1 **LONDONDERRY, NH PLANNING BOARD**
2 **MINUTES OF THE MEETING OF OCTOBER 14, 2015 AT THE MOOSE HILL**
3 **COUNCIL CHAMBERS**
4

16
17 A. Application Acceptance and Public Hearing for formal review of a site plan
18 ("57 Rear Pettengill Road") to construct a manufacturing facility and associated
19 improvements at 57 Rear Pettengill Road, Tax Map 28 Lot 17-2, Zoned GB -
20 the City of Manchester (Owner) and Anagnost Investments Inc. (Applicant).
21 J. R. Trottier stated there were no checklist items and that Staff recommends
22 the application be accepted as complete.

To: Planning Board **Date:** October 14, 2015
From: Cynthia A. May, ASLA, Town Planner
John R. Trottier, PE, Assist. Dir. Of DPW
Re: **57 Rear Pettengill Road Staff Recommendation**

Re: Tax Map 28 Lot 17-2
Proposed Site Plan for
Manufacturing Facility
57 Rear Pettengill Rd.

TAX MAP 28 LOT 17 BLOCK 2
SITE PLAN OVERVIEW
MANUFACTURING FACILITY
57 REAR PETTENGILL ROAD
LONDONDERRY, NH

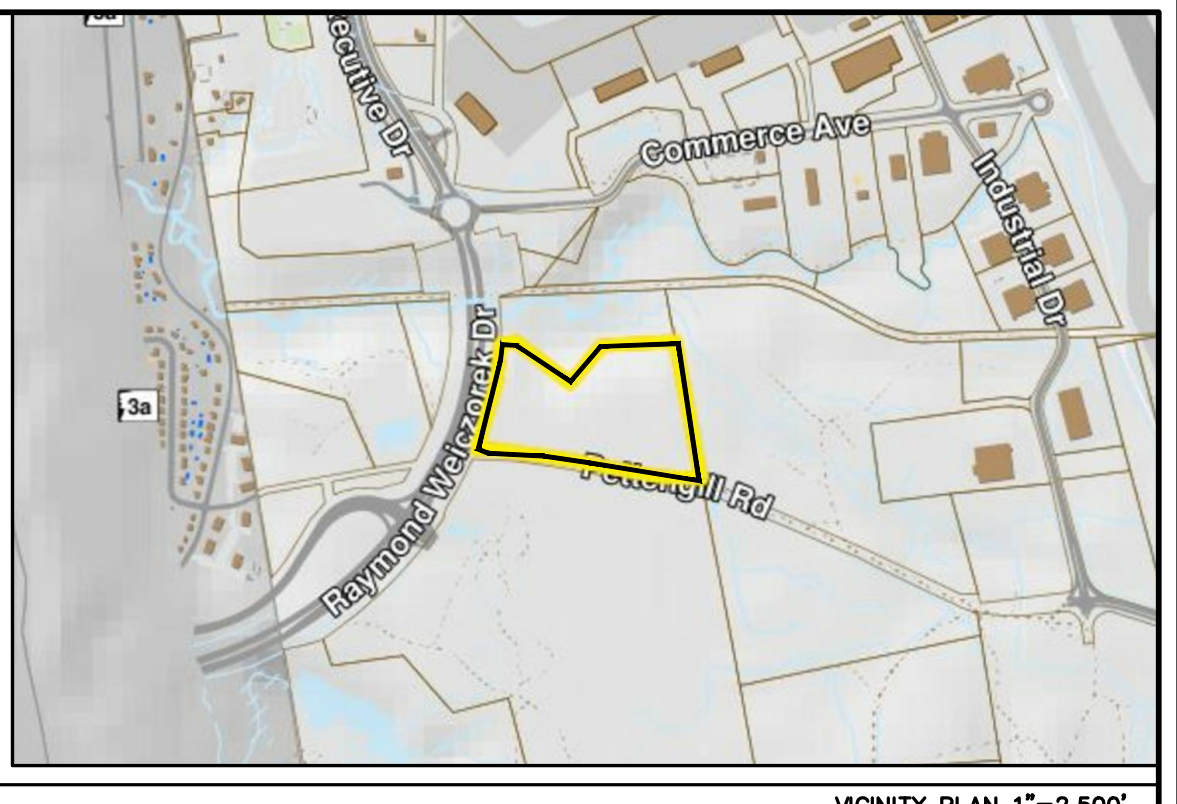
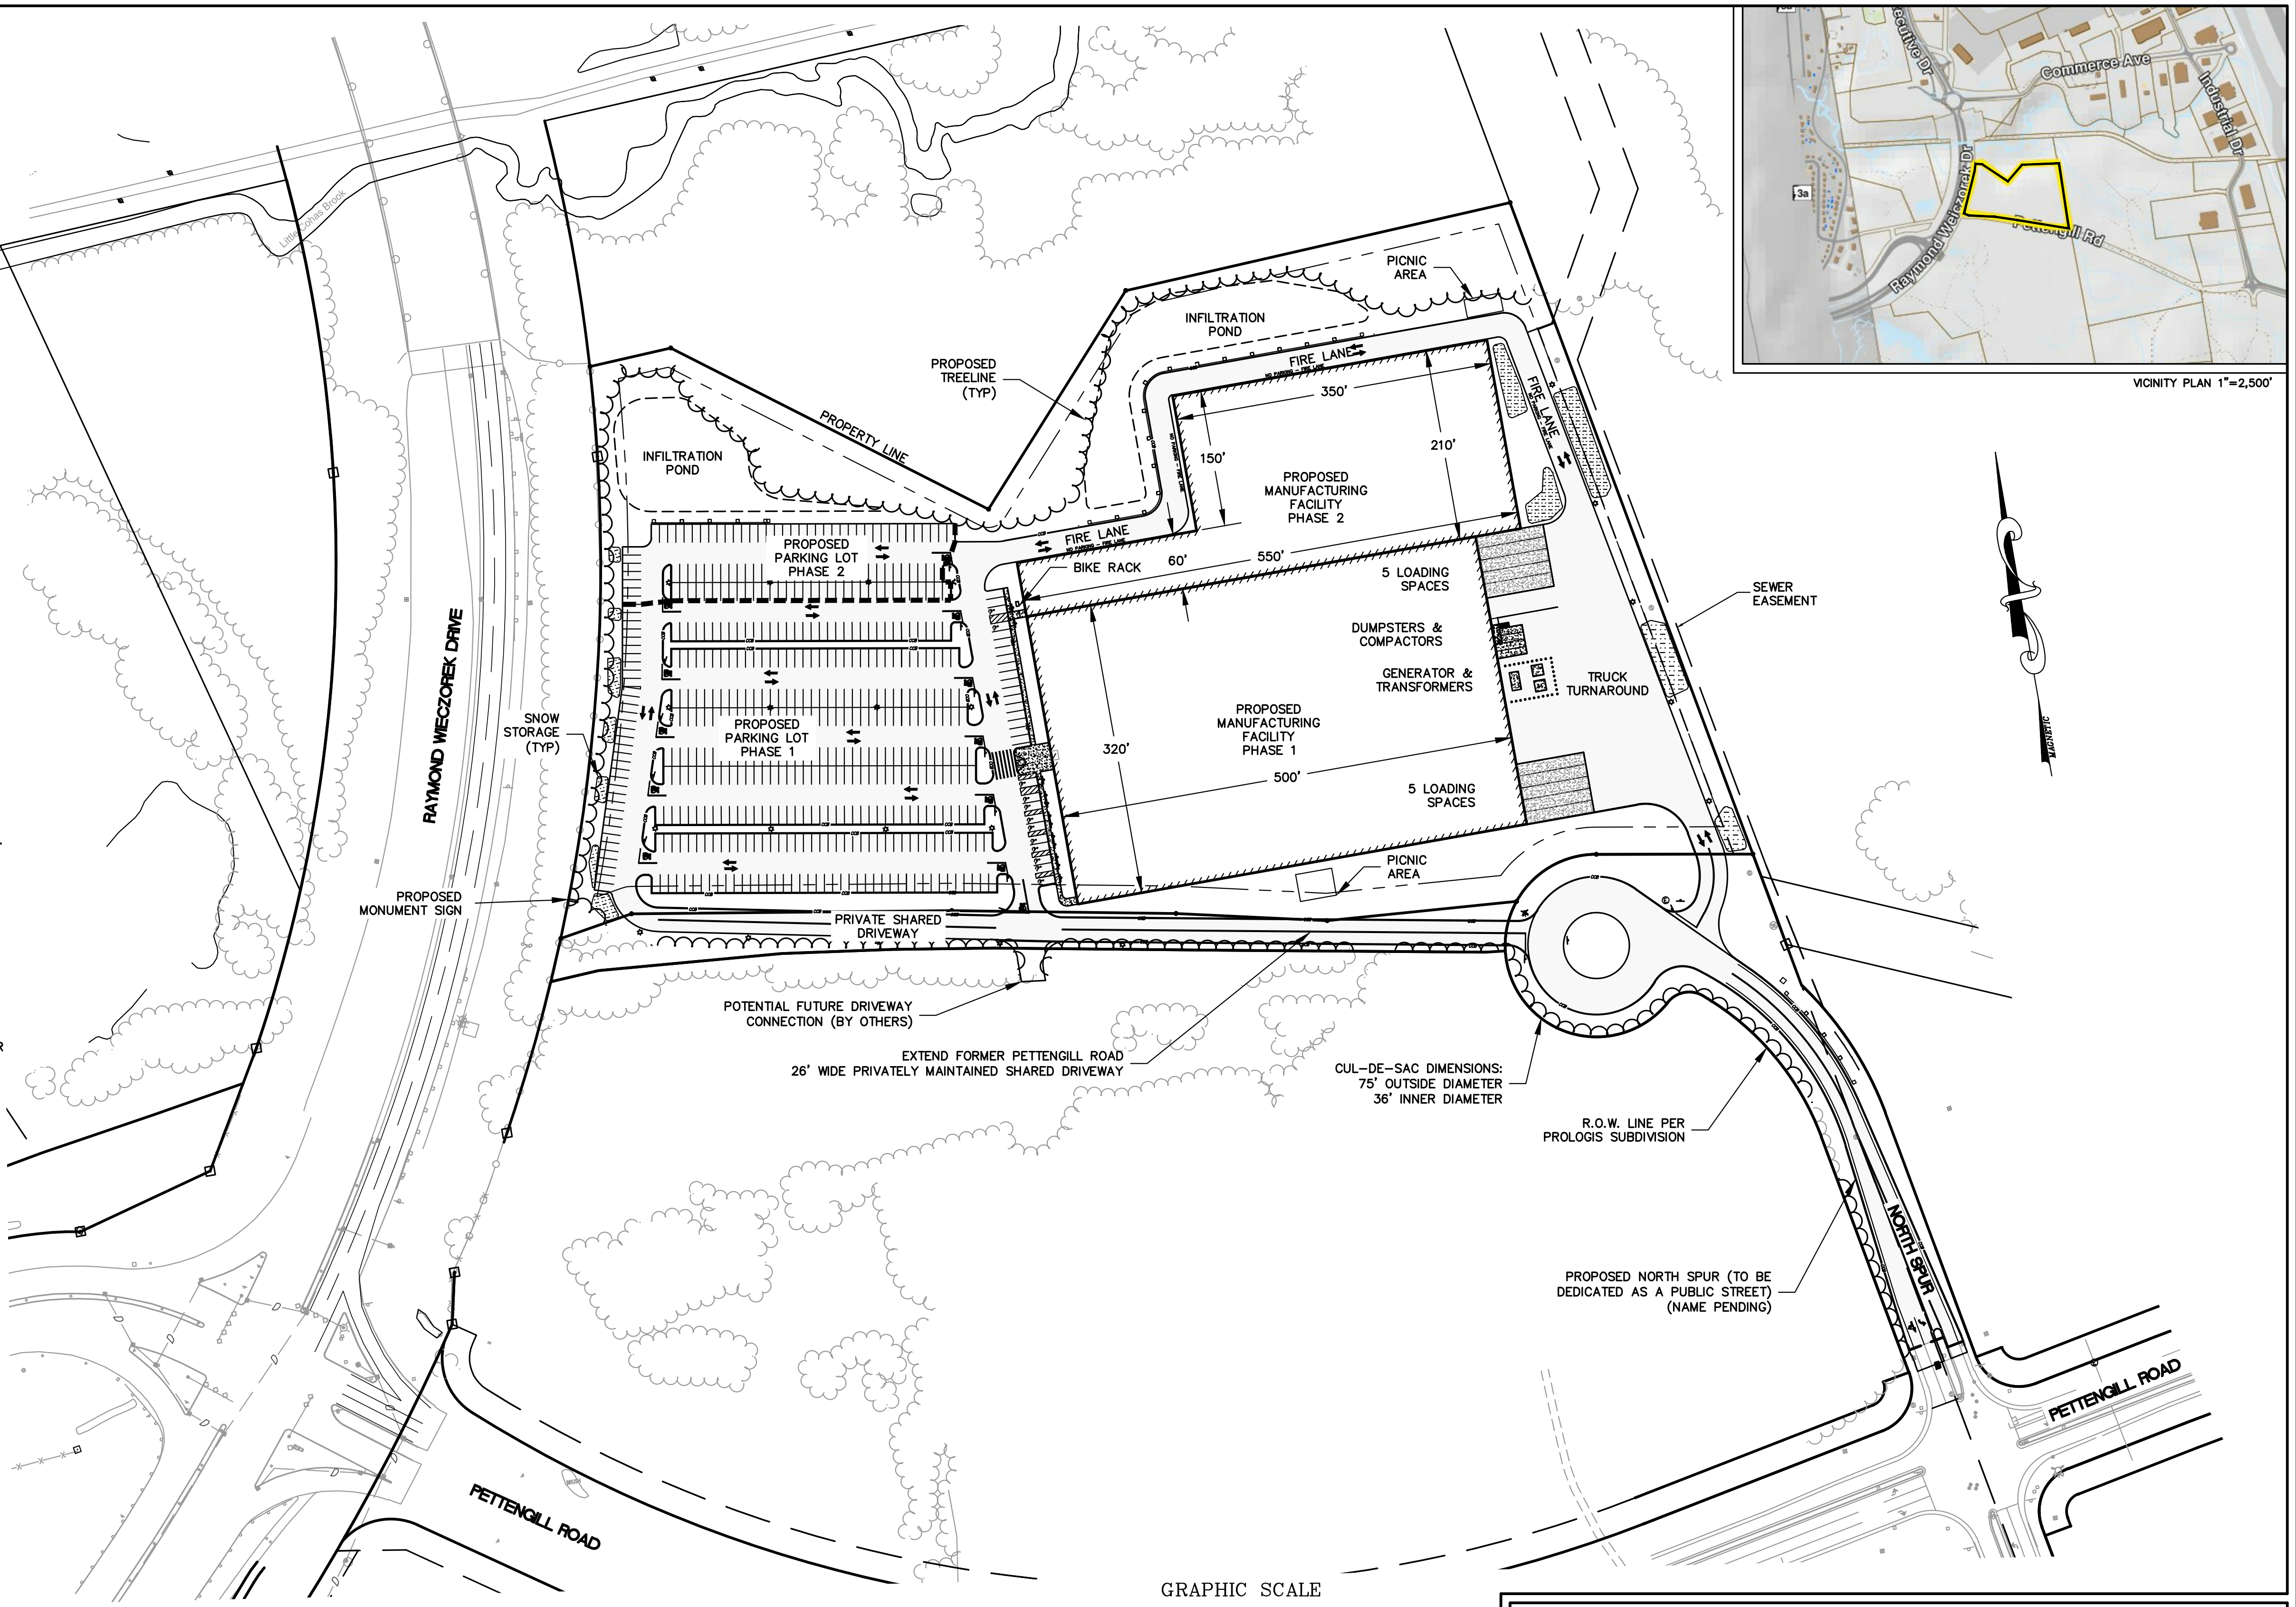
6. The existing conditions overview plan, site plan overview plan and grading and drainage overview plan are at a scale of 1"=100', which do not comply with section 4.01c of the regulations (1"=40' max.). The Applicant is requesting a **waiver** for the overview plan scale.
